**FINAL**  
**YEAR 4 (2017) ANNUAL MONITORING REPORT**  
**BEAR CREEK (PHILLIPS SITE) RESTORATION PROJECT**

Chatham County, North Carolina  
DMS Project No. 26 (Contract No. 5715)  
DWR Project No. 0713-94  
SCO No. 09-07726-01A

RE: Bear Creek (Phillips) Monitoring (DMS Project # 26, Contract #5715)  
Final MY4 (2017) Annual Monitoring Report

Axiom Environmental, Inc. (AXE) is pleased to provide you with three hard copies and a CD of digital files for the Final Bear Creek (Phillips) Annual Monitoring Report. We received your comments via email on December 22, 2017 and have addressed them as follows:

FIGURE  
**2A**

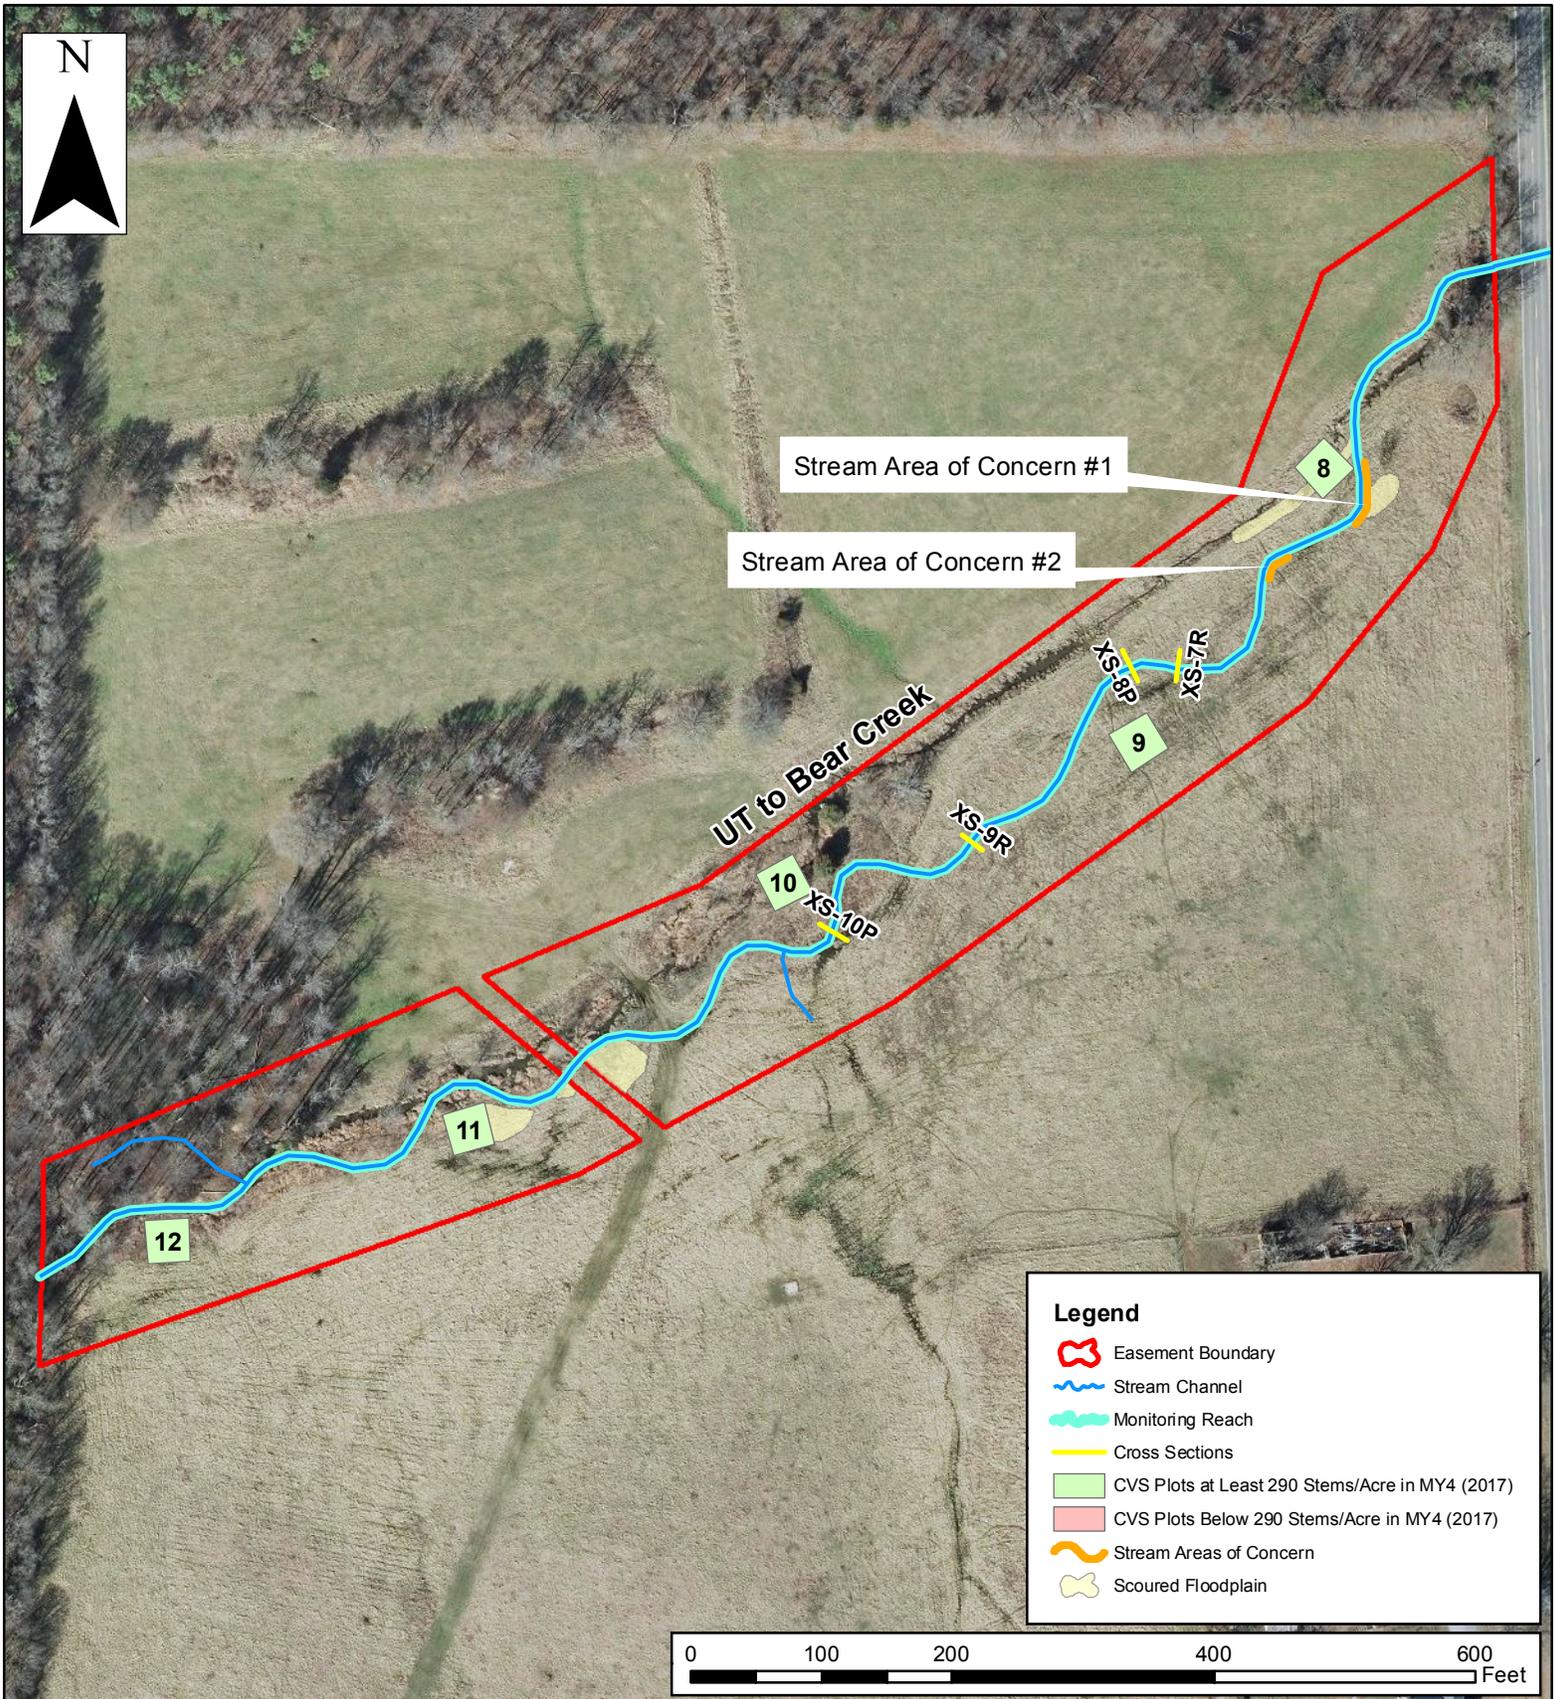
3. Section 2.1, Stream Areas of Concern, page 4: This section only refers to two areas of concern but a third is indicated in the GIS files located on the upstream side of the culverts on Bear Creek Reach 1. In addition, the third area is not depicted on the CCPV or Table 5A either. If this is no longer an area of concern, please remove from GIS files.  
*Only the two areas of concern were observed onsite during Year 4 (2017) monitoring. The shapefile in the digital submittal has been updated to reflect this.*

<b>River Basin:</b>	Cape Fear
<b>Site Name</b>	Bear Creek (Phillips Site)
<b>XS ID</b>	XS - 3, Pool (Reach 2 Downstream)
<b>Drainage Area (sq mi):</b>	4.99
<b>Date:</b>	2/16/2017
<b>Field Crew:</b>	Perkinson, Keith

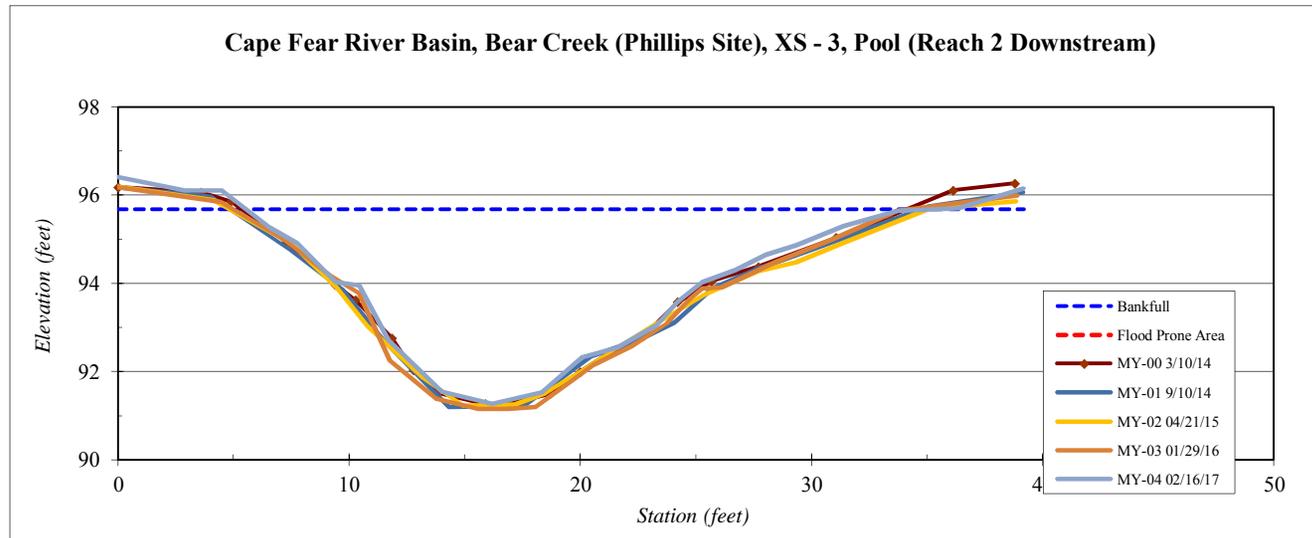
4. Appendix D: For any morphological tables, provide a footnote with the tables that describes the method by which Axiom is calculating Bank Height Ratio and Entrenchment Ratio. In addition, please provide context to any observed changes in these calculated ratios in the report narrative. DMS has proposed a method for these calculations that can be found in the As Built baseline template guidance AS-built Baseline Monitoring Report – June 2017 Page 22, specifically paragraphs 8 and 9.  
*The bank height ratios were recalculated according to the DMS method. Entrenchment ratios were checked and determined to be correct. Footnotes were added at the bottom of the tables explaining how these ratios were calculated. The following was added to the cross-section discussion in section 2.1: "Year 4 (2017) cross-section data shows little change from as-built conditions. The bank height ratio at cross-section 7 increased to 1.13, indicating a small amount of down-cutting which can be seen on the left side of the cross-section plot (Appendix D). In a small channel like the Unnamed Tributary, the bank height ratio can be greatly affected by very small changes in thalweg elevation. This cross-section will be closely monitored through year 5 (2018) but is not concerning at this time."*

Year 4 (2017) cross-section data shows little change from as-built conditions. The bank height ratio at cross-section 7 increased to 1.13, indicating a small amount of down-cutting which can be seen on the left side of the cross-section plot (Appendix D). In a small channel like the Unnamed Tributary, the bank height ratio can be greatly affected by very small changes in thalweg elevation. This cross-section will be closely monitored through year 5 (2018) but is not concerning at this time.
